# HISTORIC AND DESIGN REVIEW COMMISSION

**HDRC CASE NO:** 2018-254  
**ADDRESS:** 205 OSTROM  
**LEGAL DESCRIPTION:** NCB 6938 BLK LOT 1&2  
**ZONING:** R-4 CD, H, RIO-1  
**CITY COUNCIL DIST.:** 1  
**DISTRICT:** River Road Historic District  
**APPLICANT:** Tobias Stapleton  
**OWNER:** Tobias Stapleton  
**TYPE OF WORK:** Rehabilitation, construction of a rear addition and a two story accessory structure  
**APPLICATION RECEIVED:** June 15, 2018  
**60-DAY REVIEW:** August 14, 2018  
**REQUEST:**

The applicant is requesting a Certificate of Appropriateness for approval to:

LANDSCAPE PLAN

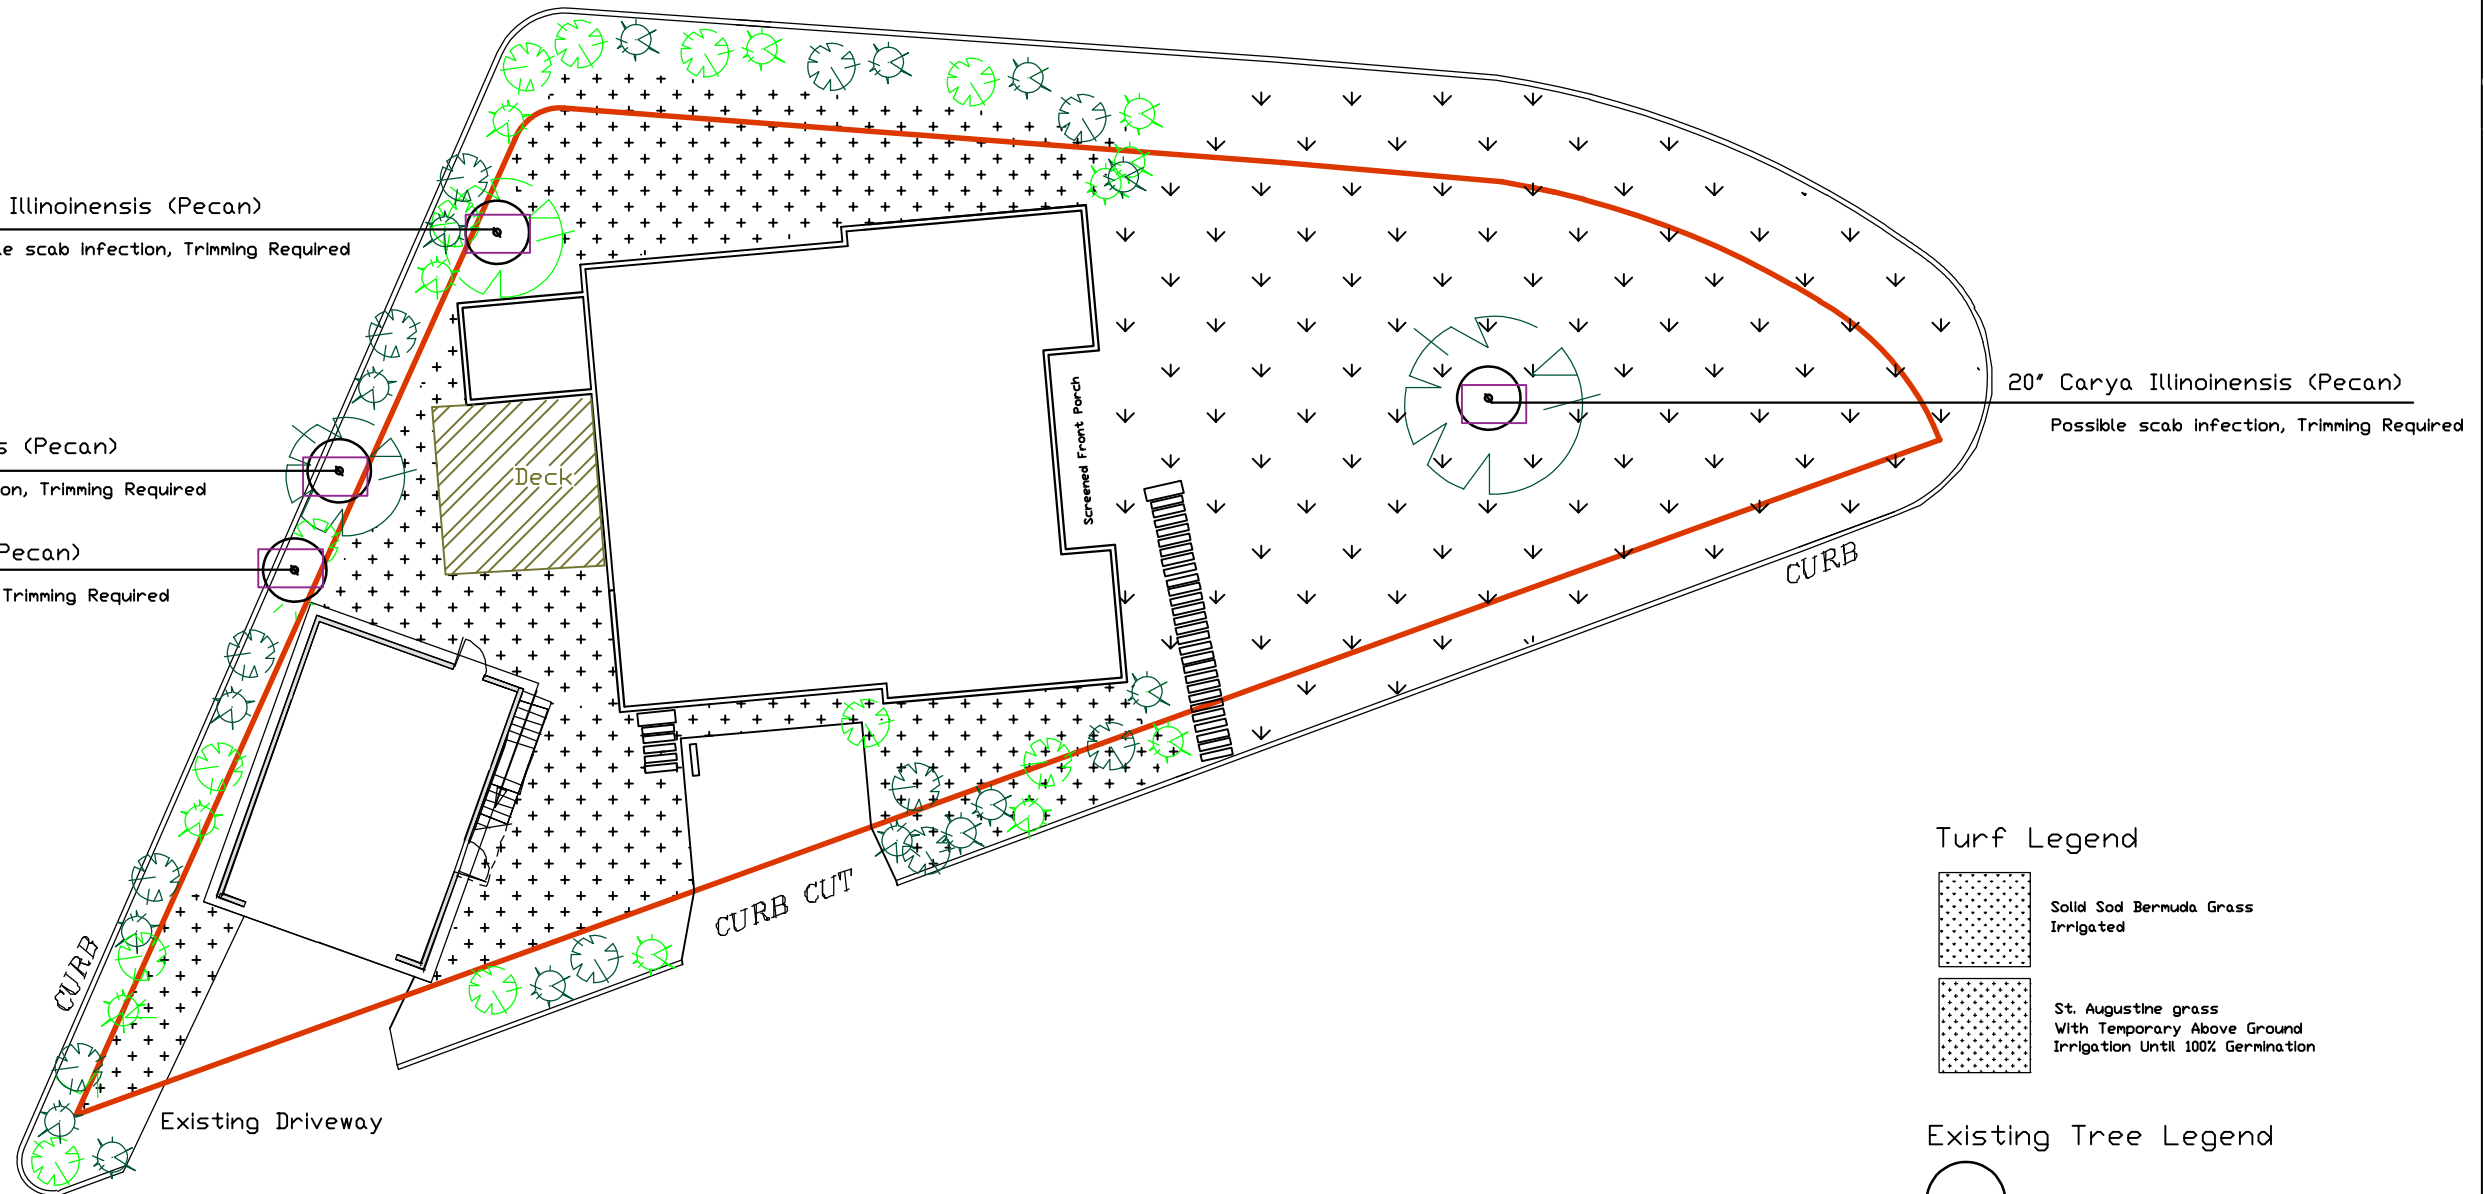
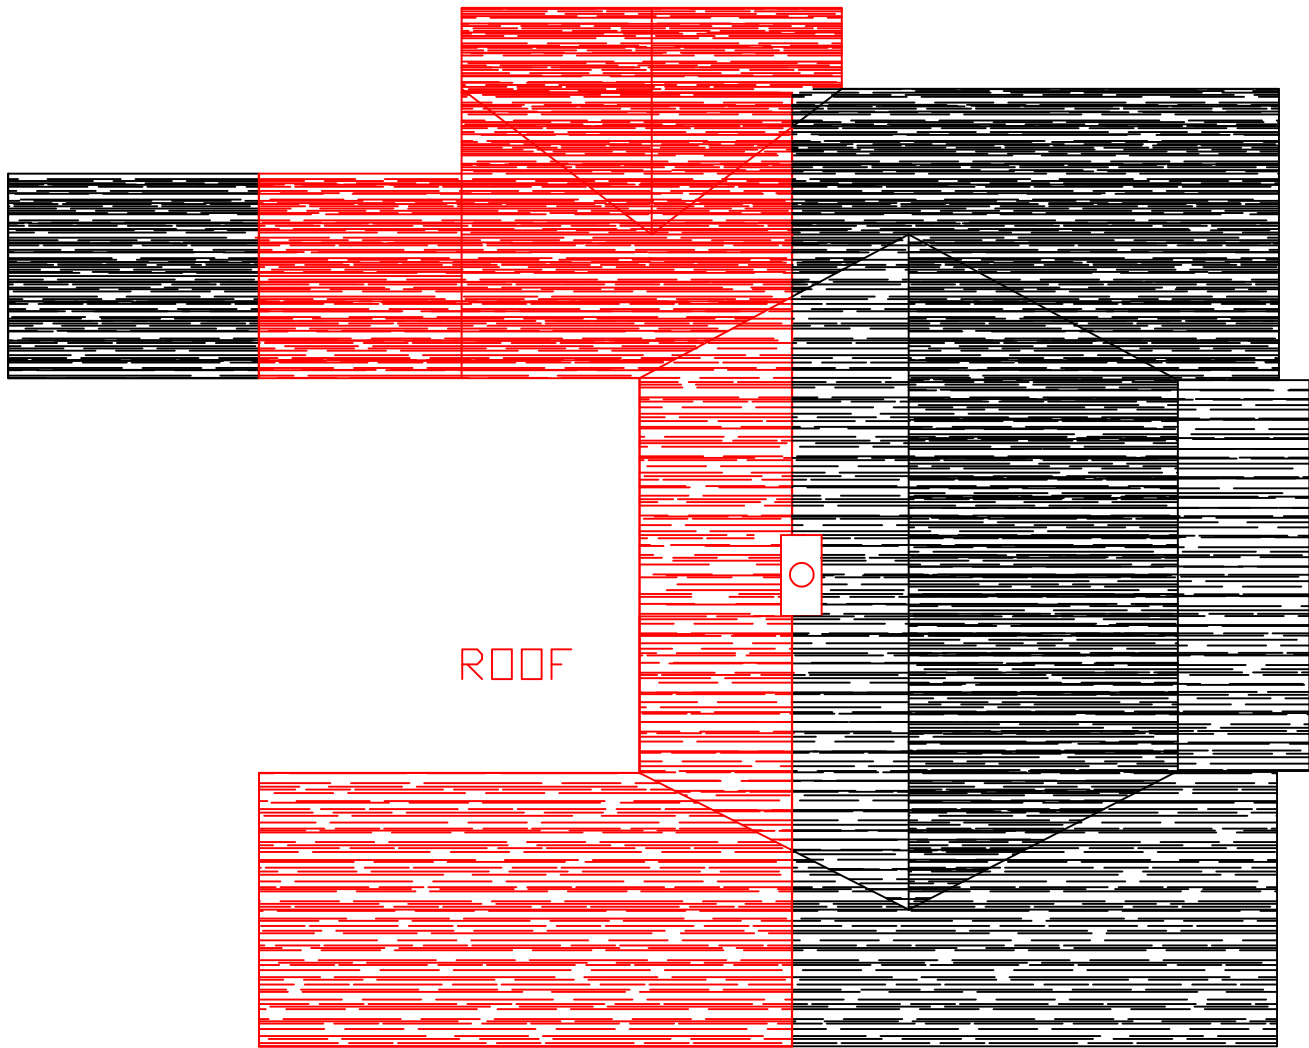
- iii. That an up-to-date site plan be provided which demonstrates tree preservation on the site. **The applicant has submitted a site plan noting the location of existing trees.**

- Existing Tree To Remain
- Existing Tree To Be Removed
- Tree Protection Fencing To Remain During Construction

Screened in Porch  
& Shed roofs awning  
Details  
SP-104

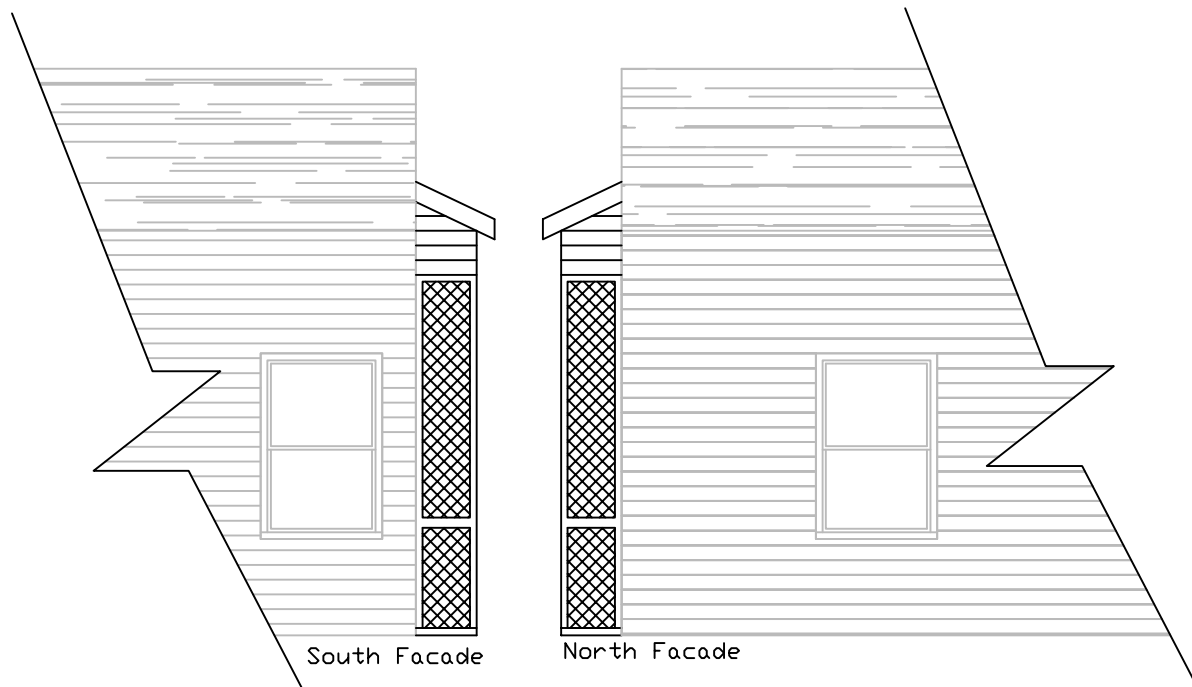
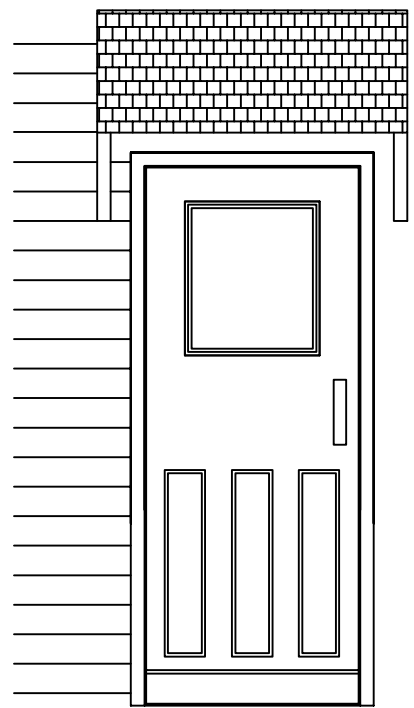
- ii. That shed roofs or small traditionally detailed awnings could be added above doors on the proposed addition. **The applicant has submitted construction documents noting this addition.**

Door Awning's Typical ea. door  
Shingle to match existing

WS-501

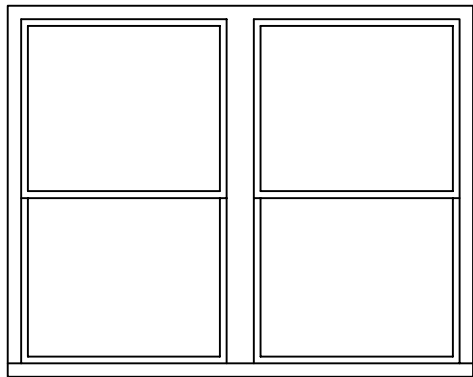
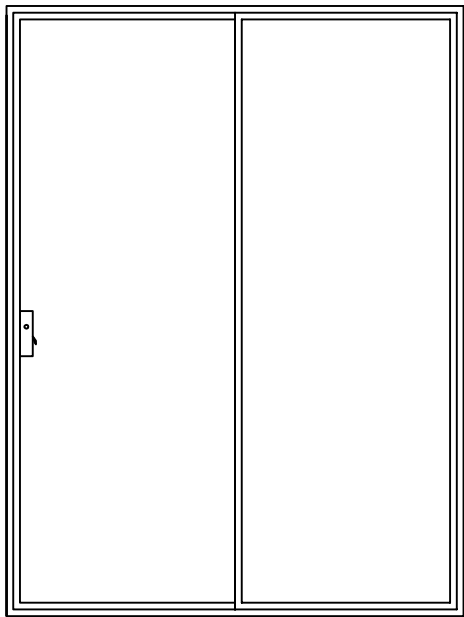
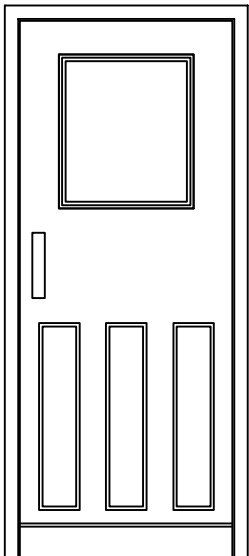
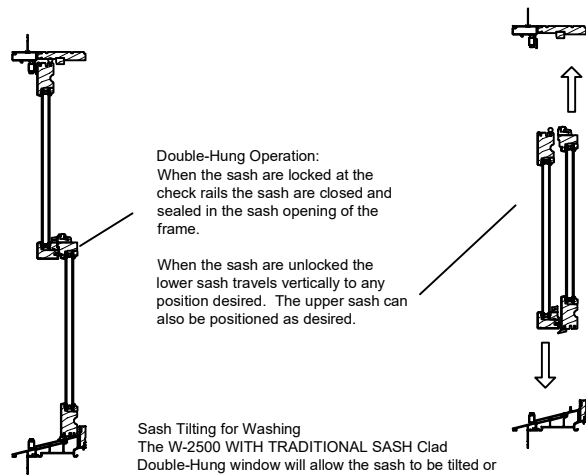
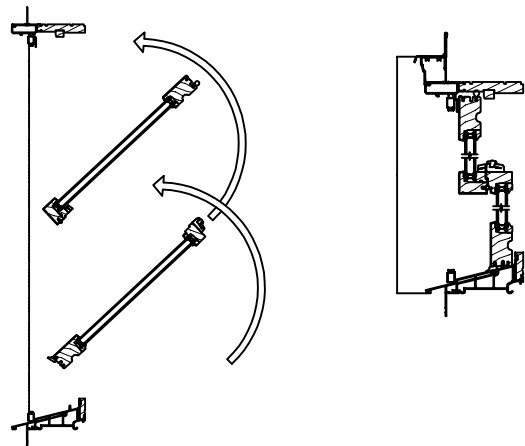
- i. That the applicant provide information regarding new windows when returning for final approval. **The applicant has submitted information regarding new, wood windows.**

We are working with JELD WEN (Roger Bianco) to match the existing windows at 205 Ostrom Drive as well as meeting the requirements set out by the HDRC

### Archaeology Plan

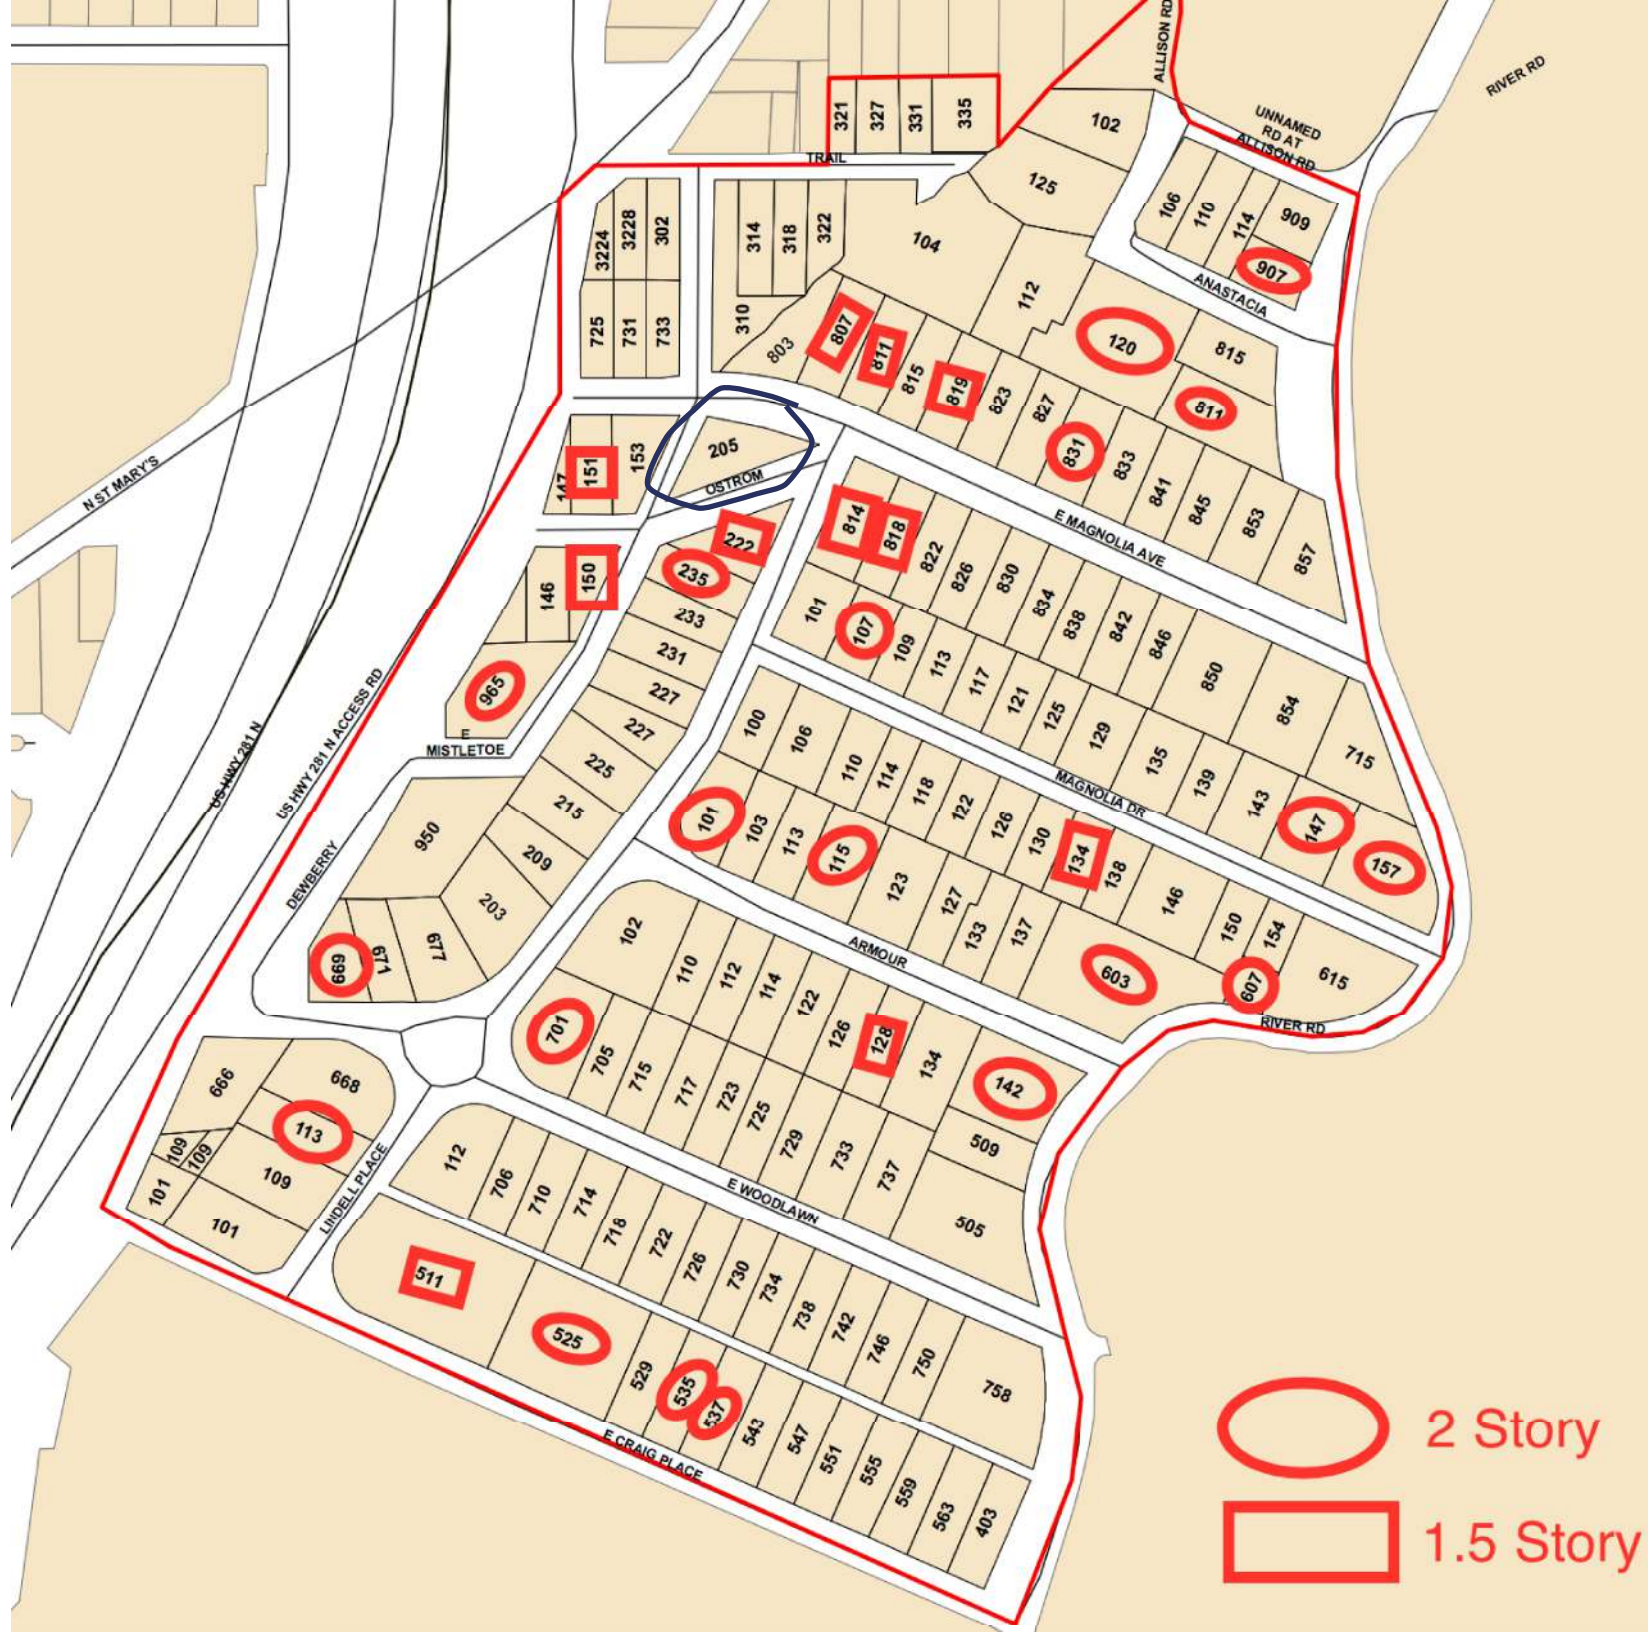
- iv. ARCHAEOLOGY- An archaeological investigation is required. The archaeological scope of work should be submitted to the OHP archaeologists for review and approval prior to beginning the archaeological investigation. The development project shall comply with all federal, state, and local laws, rules, and regulations regarding archaeology. **The applicant has coordinated with OHP archaeologists regarding archaeology requirements.**

In talks with Matthew Elverson of the OHP Archaeological dept. as well as forwarding the stipulation by HDRC, he has requested that my plan be limited to informing him 48hrs in advance of deep trench excavation on site.

He does not see that demolition is a concern but new trenching would need to be looked at.
